# UNITED STATES PATENT AND TRADEMARK OFFICE

APPLICATION NO.	FILING DATE	FIRST NAMED INVENTOR	ATTORNEY DOCKET NO.	CONFIRMATION NO.
10/769,776	02/03/2004	Kenichi Shiba	Q79666	9279
23373	7590	08/23/2005	EXAMINER	
SUGHRUE MION, PLLC 2100 PENNSYLVANIA AVENUE, N.W. SUITE 800 WASHINGTON, DC 20037			CHEN, WEN YING PATTY	
			ART UNIT	PAPER NUMBER
			2871

<b>Office Action Summary</b>	<b>Application No.</b> 10/769,776	<b>Applicant(s)</b> SHIBA, KENICHI	
	<b>Examiner</b> Wen-Ying P. Chen	<b>Art Unit</b> 2871

FIG. 6

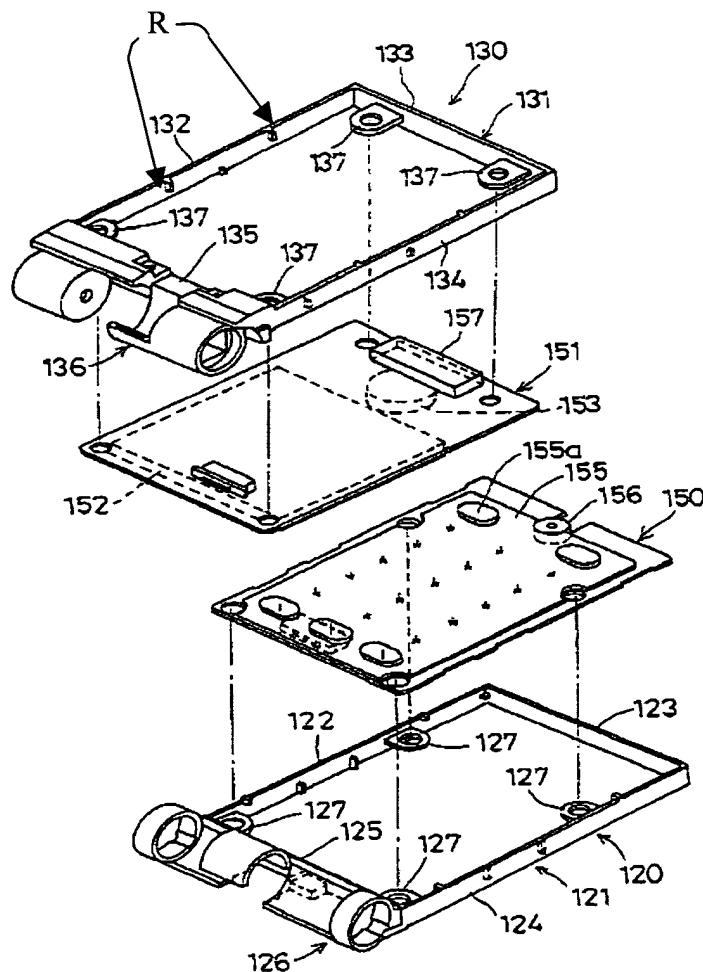
Takagi discloses all of the limitations set forth in claim 1 and further disclose in Figure 6 that the display comprises a frame portion (element 130) with mechanisms (element R, as shown in figure below) formed integrally with the frame portion that pushes the display against an inner face of the second casing body.

Takagi fails to disclose that the mechanisms (element R) which pushes the display have resiliency.
